Re: Percolation Test Report; 14700 Carriage Mill Road

14700 Carriage Mill Road

Good afternoon. The perc cert plan for 14700 Carriage Mill Road has been reviewed with the following comments:

PROJECT: **DORSEY RESIDENCE HOME ADDITION**

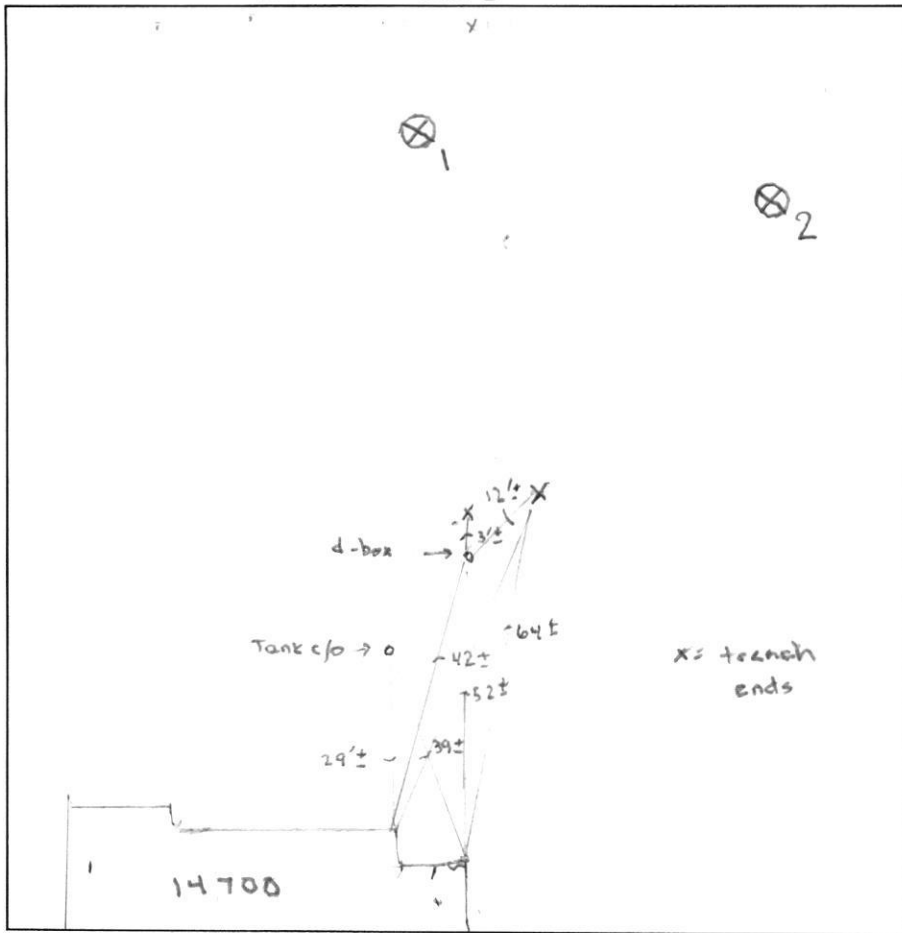
DATE	TEST #	DEPTH	START	BREAK 1" DROP	STOP 2" DROP	TIME OF 2ND INCH	P/F/H
10.11.22	1	6' / 13'	8:09	8:18	8:38	20	P
10.11.22	2	5'5" / 13'	8:21	8:27	8:36	9	P

1  
 0.2' br l  
 yellowish  
 br scl  
 2' red br  
 scl  
 5' yellowish  
 red  
 sl  
 13'

2  
 0.1' br l  
 yellowish  
 br scl  
 4.5' yellowish  
 red sl  
 8' pak red  
 sl  
 13'

DRAWING: **SECOND FLOOR PLAN - NEW**  
 SCALE: 3/16" = 1'

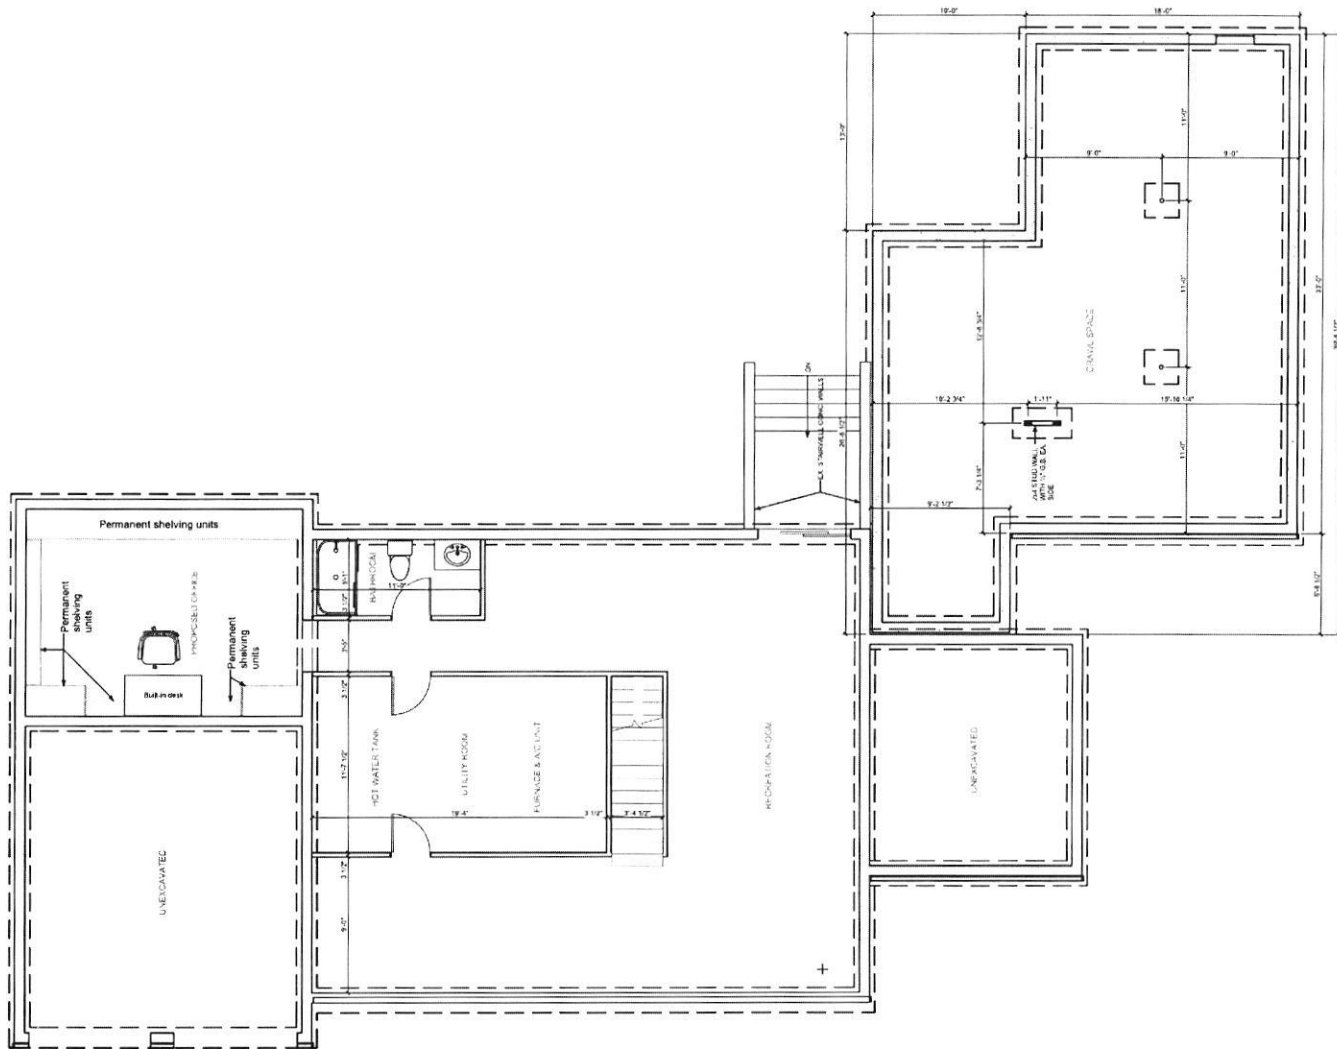
The existing floor plan (5 BRs) plus proposed addition (2 BRs) = 7 BRs. **Please note**, the floor plan (see attached) which shows 4'1" opening into the "office" on the 2<sup>nd</sup> floor of the proposed addition must be submitted to DILP as a revision. In addition, the 12' x 18' room in the basement next to the full bathroom also meets the definition of a bedroom (see attached bedroom definition). To reduce the BR count, you could alter the floor plan by one of the following;

1. Show 4 foot (48 inches) wide opening without door into the room, **or**
2. Show permanent built-in bookcases around the perimeter of the room, desk and other features that encumber the room, **or**
3. Show a half wall between the room and another room.
